REPLACING PAGE ADDENDUM
Filing Instructions:

197- AND 198-TYPE SWITCHES
BANKS, COMMUTATORS, WIPERS, JACK SPRINGS
AND SWITCH OPERATION
REQUIREMENTS AND ADJUSTING PROCEDURES

1.001 This addendum supplements Section 030-705-704, Issue 8. The attached pages must be inserted in the section in accordance with the filing instructions above.

1.002 This addendum is reissued to:

Fig. 3—Alignment of Wipers with the Bank Levels

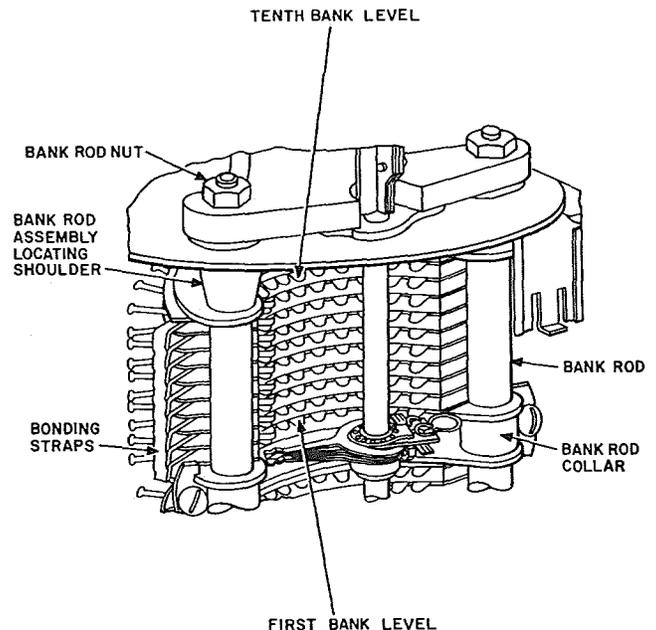
- (a) 2.10(b)—revised
(b) Table in 2.10(b)—revised

- (b) The horizontal centerline between the tips of the wiper springs shall coincide with the centerline of the bank contact levels when the wiper is about to cut in on the bank.

Gauge by eye as covered in the following table.

TYPE OF SWITCH	SWITCH ARRANGED TO TAKE		CHECK REQUIREMENT ON	
	VERTICAL STEPS	ROTARY STEPS	CONTACTS	BANK LEVELS
†197	10	11	1	5
197	10	10	1	5
†197	5	11	1	3 & 8
197	5	10	1	3 & 8
198	—	—	1	Operating

† On 200-point banks having the insulators extending to the eleventh rotary position, the requirement shall be checked on the first contact only.

- (1) If requirement 2.10(b) is not met, adjust the wiper springs in accordance with (a) or (b).

SWITCHES STEPPING 10 BANK LEVELS

(a) The shaft will be raised to the fifth level, then loosen the setscrew in the wiper hub with either the 3-inch C screwdriver or the 555A wrench. Turn the shaft and wiper in to the first bank contacts, adjust the wiper up or down until the wiper tips rest on the bank contacts at equal angles. Now tighten the setscrew with the fingers and return the switch to rotary normal. Then recheck the wiper at cut-in on the fifth level to make sure the wiper does not duck upward

or downward at cut-in. If ducking occurs, readjust the wiper to eliminate all ducking. Wiper blades will now deflect equal amounts to accept the bank contacts at cut-in.

SWITCHES STEPPING 5 BANK LEVELS

(b) The shaft will be raised to the third level, then loosen the setscrew in the wiper hub with either the 3-inch C screwdriver or the 555A wrench. Turn the shaft and wiper in to the first bank contacts, adjust the wiper up or down until the wiper tips rest on the bank contacts at equal angles. Now tighten the setscrew with the fingers and return the switch to rotary normal. Then recheck the wiper at cut-in on the third level to make sure the wiper does not duck upward or downward at cut-in. If ducking occurs, readjust the wiper to eliminate all ducking. Wiper blades will now deflect equal amounts to accept the bank contacts at cut-in. Repeat the above described procedure for the second wiper except adjust to the eighth level.
